DEPT.)F		
Cit	y of Portland, Maine - Bui	lding or Use	Permit Application	Pe	rmit No:	Issue Date:	<u>, </u>	CBL:	<u> </u>
	Congress Street, 04101 Tel:	_		- 1	05-1658	1 1		083A B	001001
Loca	tien Construction:	Owner Name:	· · ·	Owne	r Address:		TEA .	/ Phone:	
0 N	leadow Ave - Great Danied	Meandrew Ro	bert R Etal Jts	451	Deming St	1 1		7	
Busi	ness Name:	Contractor Name		Contr	actor Address:	$I_{ij} = I_{ij}$, Januaria	Phone	
	<u>/</u>	Leddy Houser	Assoc	429	Preble St Por	dind	Ľ.,	20776709	03 ∫
Less	ee/Buyer's Name	Phone:		Perm	it Type:		·		Zope:
	<u> </u>	<u> </u>		Sin	gle Family				IKS
Past		Proposed Use:		Perm	dt Fee:	Cost of Worl		CEO District:	7
Vac	cant Land	Single Family	foundation only		\$381.00	\$40,00		1	
		}		FIRE	E DEPT:	Approved	l	roup: 5	T-05-7
		I Ray				Denied	Use G	10up: \(\sqrt{1}	19pc; 3 /
		USEPTI A	ATT THE STATE OF					Van	07120N
Prop	osed Project Description:	1/1/		ורי				11/20/	aci

Sin	gle Family foundation only			sina	iture:		Signan	шre: / ////	Lune
	-	The De	C	100	STR AN ACTI	VITIES DIST	RICT (P.A.D.)	Journal of the State of the St
		91 4	200	مزيلك	a: Approx	red □ Abo	roved w	/Conditions	Denied
		173	177						
				Signa	iture:	_		Date:	· <u>-</u>
		pplied Fo

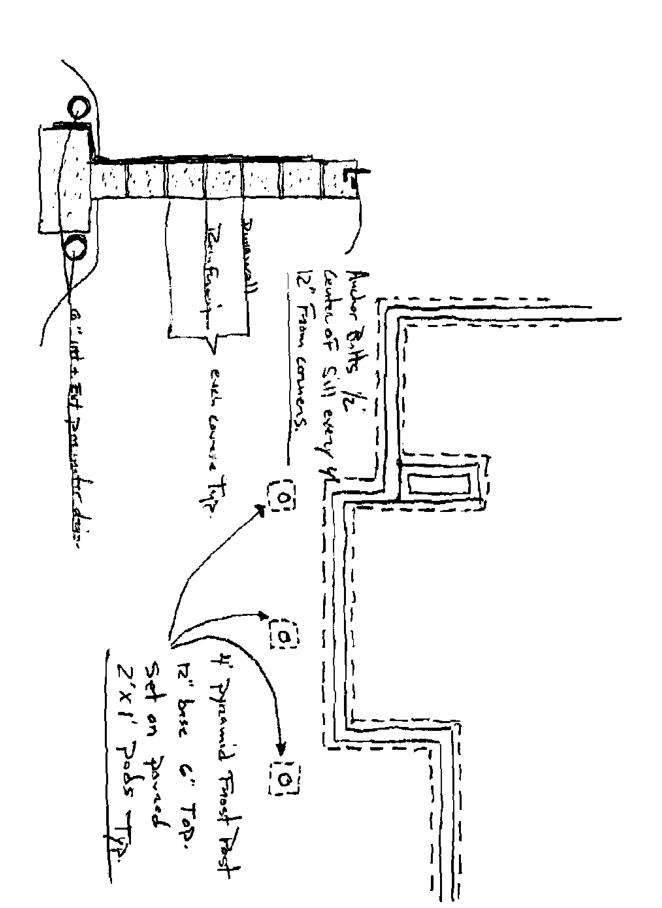
12/23/2005-amachado: Peter brought in a stamped site plan. No projections are shown on plan except proposed deck. Need to know if there will be any steps etc. Left message with Leddy Hauser.

12/27/2005-mjn: Need: Anchor Bolts, Footing and foundation dimensions, perimeter drain shown in the inside only??? Sonor tube dimensionsn depth and anchorage. Left message with Leddy Hauser.
